NANTUCKET HISTORICAL COMMISSION

June 8, 2021

RE: Nantucket Sewer Force Main #3
MHC # RC.60870

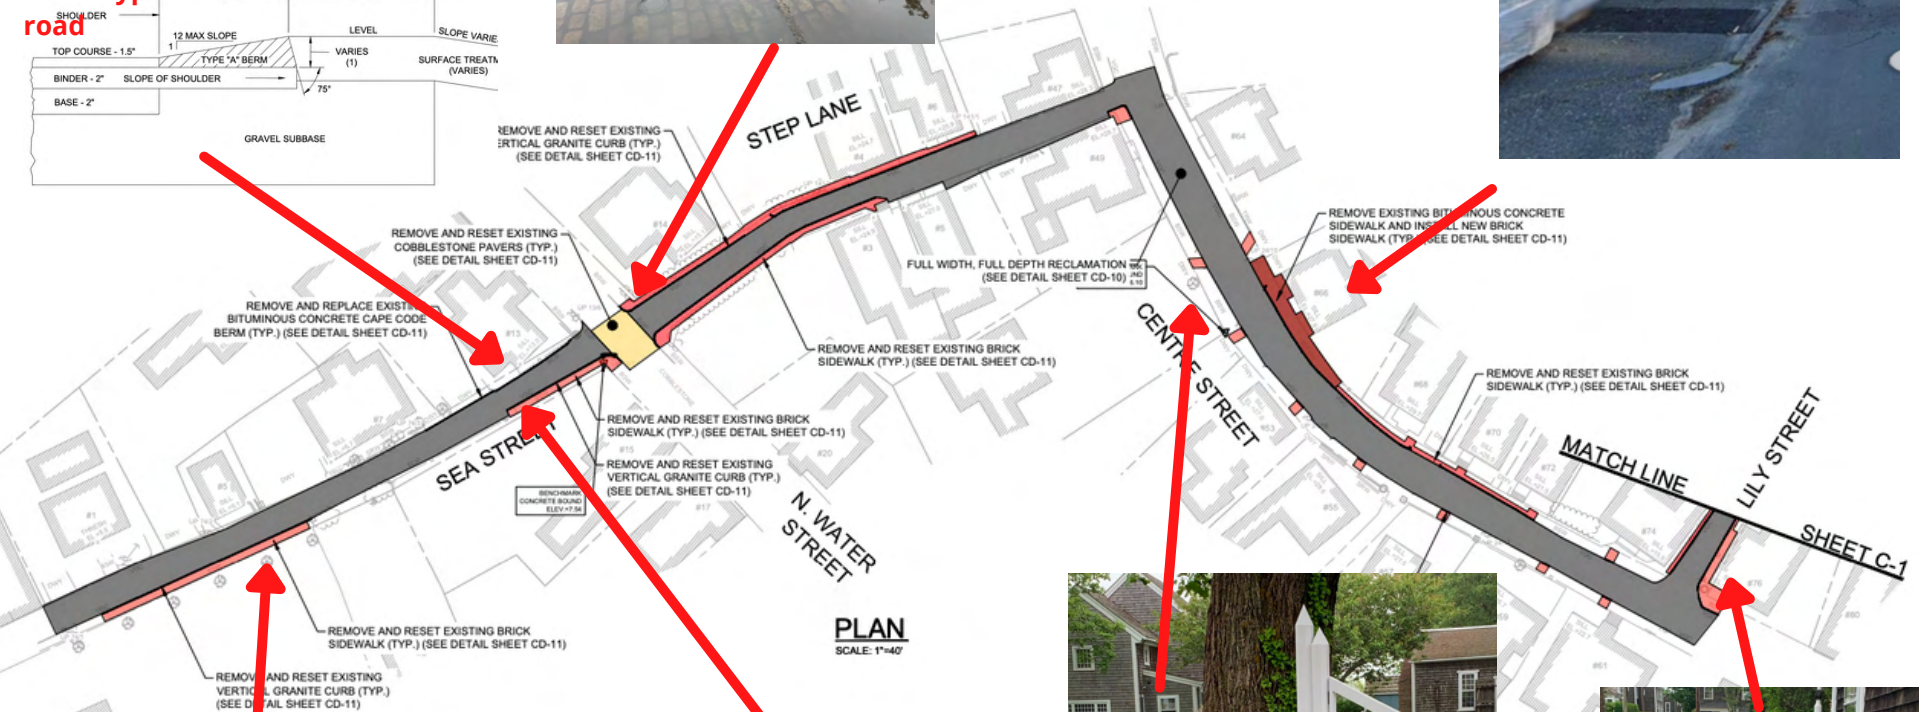
I've attached the NHC observations and photos the NHC noted on the 75% plan, that we shared with you in our meeting. One thing we forgot to mention is the cross slope of sidewalks along the route. MA CMR 521 allows for a cross slope of 2%. The 75% plans specify a cross slope of 1.5% max. We were curious if it wouldn't be advisable to allow a maximum of 2% cross slope, should conditions require it.

ATLANTIC AVENUE

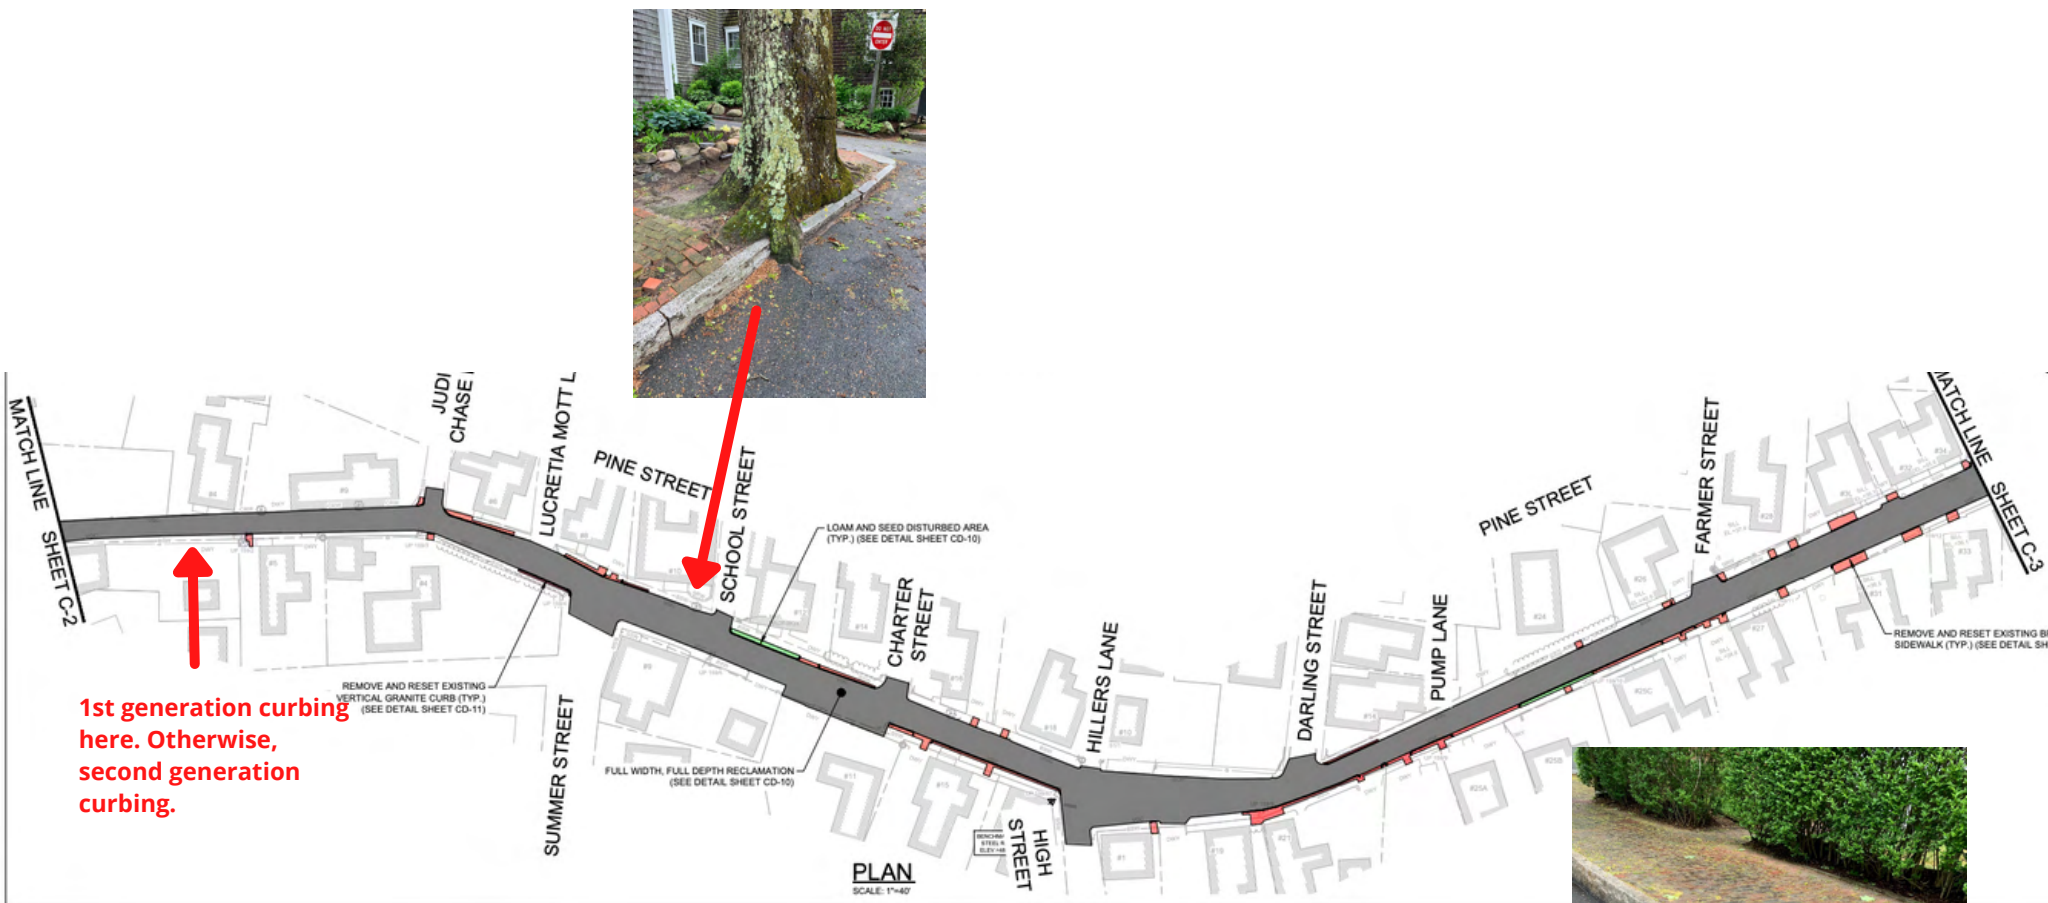
Concrete bollards to remain

Need additional detail about specification for stone sidewalk

There are pink spaces throughout with no notes -- are these being restored?

Stone: dry set vs. cement; ADA concern? Placement.

very large important tree, wrapped around curb

Would this area benefit from rehabilitation?
Surface change?
